### SUPPLEMENTAL / BID BULLETIN NO. 6

PR NO. HO-PIG25-002 / REF. NO. PB250408-AM00075  
SUPPLY, DELIVERY, CONSTRUCTION, INSTALLATION, TESTING AND  
COMMISSIONING OF 10MVA MASBATE (MALINTA) SUBSTATION

08 MAY2025

1 FOUNDATION LAYOUT  
SCALE 1:75

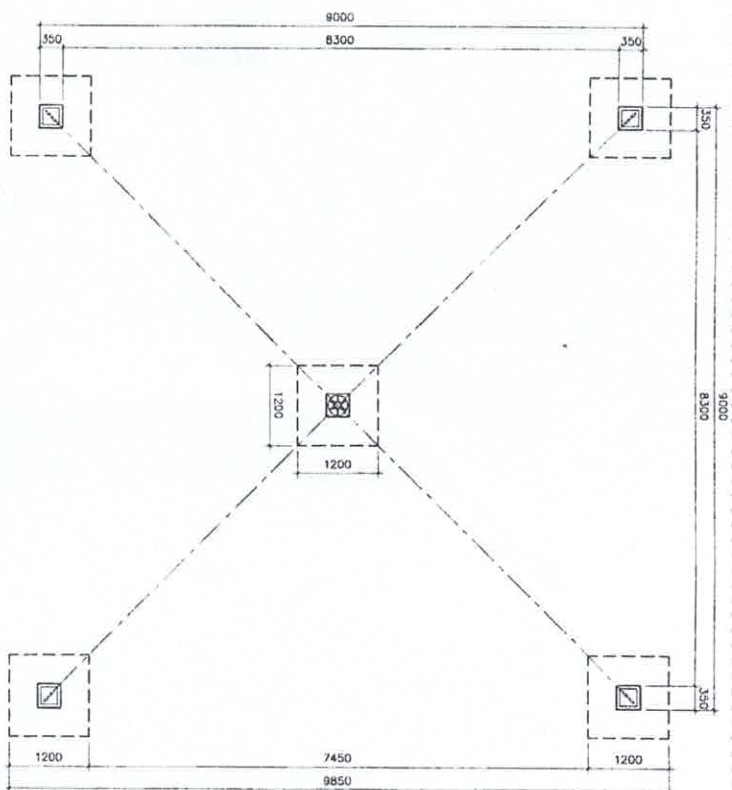
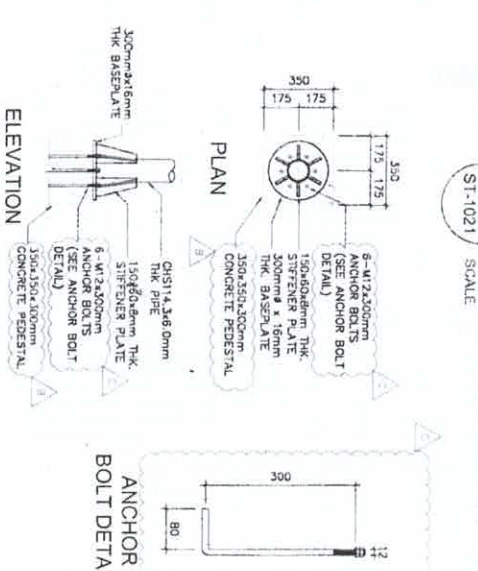
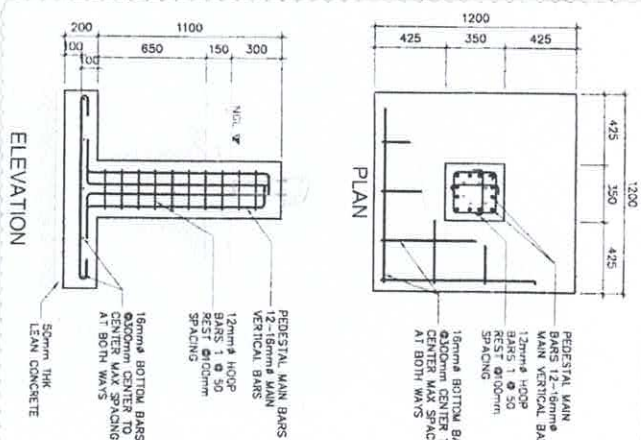
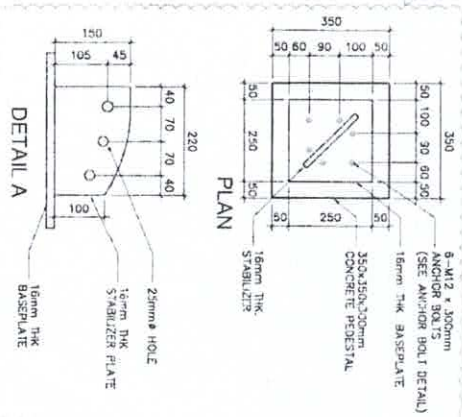
REVISION NOTES:	
A	UPDATED DISTANCE OF PEDESTAL
B	UPDATED PEDESTAL SIZES
C	UPDATED SIZES OF ANCHOR BOLTS
D	UPDATED DETAIL DRAWINGS
